APPLICATION NO.	FILING DATE	FIRST NAMED INVENTOR	ATTORNEY DOCKET NO.	CONFIRMATION NO.
10/825,918	04/16/2004	Christopher Huston	13833	8919
7590 ORUM & ROTH 53 W. JACKSON BLVD CHICAGO, IL 60604		EXAMINER EPPES, BRYAN L		
		ART UNIT 3635		
		MAIL DATE 12/26/2007		
		PAPER NUMBER PAPER

Office Action Summary	Application No. 10/825,918	Applicant(s) HUSTON ET AL.	
	Examiner Bryan Eppes	Art Unit 3635

DETAILED ACTION

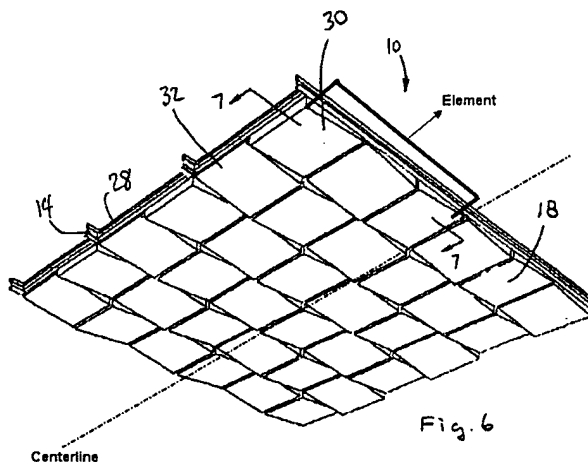
a. Claim 25. Wendt discloses a plurality of acoustical elements comprising a frame 28 and a plurality of angled paddles 18, each having an upper side and lower side; the element between pairs of ceiling joists 14 in a symmetrical pattern about an imaginary centerline running perpendicular to the joists 14 (See Modified Fig. 6). Examiner interprets each "element" as comprising any 3 abutting paddles running parallel with the joists, for example the plane 7 is being construed as a cross section of an "element."

b. Claim 26. Wendt discloses a first acoustical element between joists 14 at a first side of the imaginary centerline;

a second acoustical element at the opposite side of the imaginary centerline between the joists, such that they meet and form a V-shape or inverted V-shape;

additional elements between the pair of joists such that the paddles 18 angle the same direction as the paddles in the adjacent acoustical element, in this case, where the paddles meet in the middle they angle in the same direction and likewise alternate directions moving away from the centerline;

acoustical elements between the remaining pairs of joists; and

alternating the V-shape between adjacent joists (See Modified Fig. 6).
